**Re: Sugarloaf West Mountain Expansion
Response to MDIFW and MNAP Comments**

INITIAL RESPONSES TO COMMENTS BY MAINE DEPARTMENT OF INLAND FISHERIES AND WILDLIFE AND MAINE NATURAL AREAS PROGRAM

Figure 1: Culvert Removal / Replacement

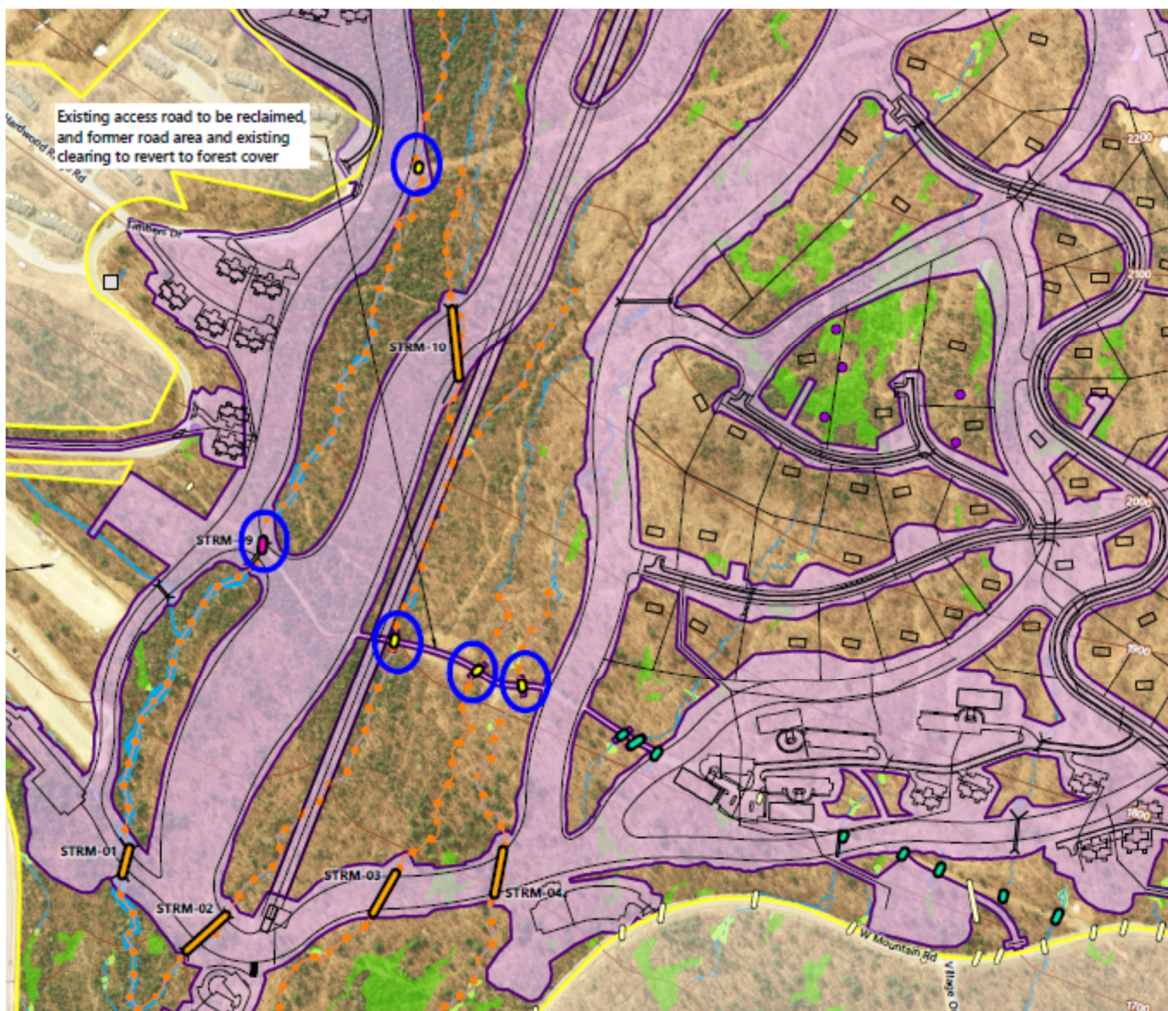
In reviewing the MDIFW comments, there appears to be some confusion as to what is being offered as part of the mitigation package for the Roaring Brook Mayfly (RBM) and Northern Spring Salamander (NSS). The Applicant offers the following clarification of what is being offered for mitigation:

Overall Approach: It is well documented that closed conduit pipe culverts with perched outlets can present significant obstacles for passage aquatic species. Several such existing culverts currently exist at the lower portions of the RBM/NSS Project area, thus restricting access to the majority of the potential habitat within the Project area (see Figure 1 below). Under proposed conditions, the Applicant's proposed mitigation approach removes these existing obstacles within the RBM/NSS stream channels resulting in significant net expansion of aquatic organism mobility and restoration of access to suitable habitat as described below.

Replacement Culvert: The Applicant is proposing that the replacement of the existing perched culvert at stream crossing #9 with an open bottom arch crossing be considered mitigation (see Figure 1 below). The Applicant appreciates that mitigation credit is not granted when a component of a Project adheres to the existing standard (such as the new pipe culverts being installed). However, in this case siting the crossing at this location was not done for design purposes and in fact additional new crossings would have presented better resort functionality and skiable terrain. Instead, out of deference to the MDIFW's

request to utilize existing disturbed areas, the Applicant proposes an upgrade to this existing crossing at significant investment to bring it to compliance with current standards and more importantly, to improve the upstream habitat and improve mobility within the stream corridor. The Applicant has assigned a proposed improved habitat area to use in the mitigation ratio, as outlined below.

Culvert Removal: The Applicant is proposing to remove four existing perched culverts (see blue circles on Figure 1). The Applicant is not obligated to remove these culverts as they are not part of the Project design and in fact doing so poses an inconvenience to mountain operations given their location along an existing access and maintenance road. However, removal of these culverts and existing access road surfaces was discussed in several preapplication working sessions with MDIFW where the Department reinforced that this mitigation approach was appropriate in that it provides valuable improvement to organism passage to suitable upstream habitat along the existing stream channels.

The Applicant believes that a critical issue for the upcoming discussion will be to determine the value of the mitigation package being offered. By voluntarily removing four culverts and replacing another one, the Applicant anticipates re-establishing habitat access to approximately 13,973 linear feet of streams within the Project area. Given the proposed width of stream crossings with potential habitat is estimated at 985 feet, the Applicant is providing a 14:1 mitigation ratio and therefore respectfully contends that a net expansion of habitat accessibility results from the Project and no further mitigation is necessary.
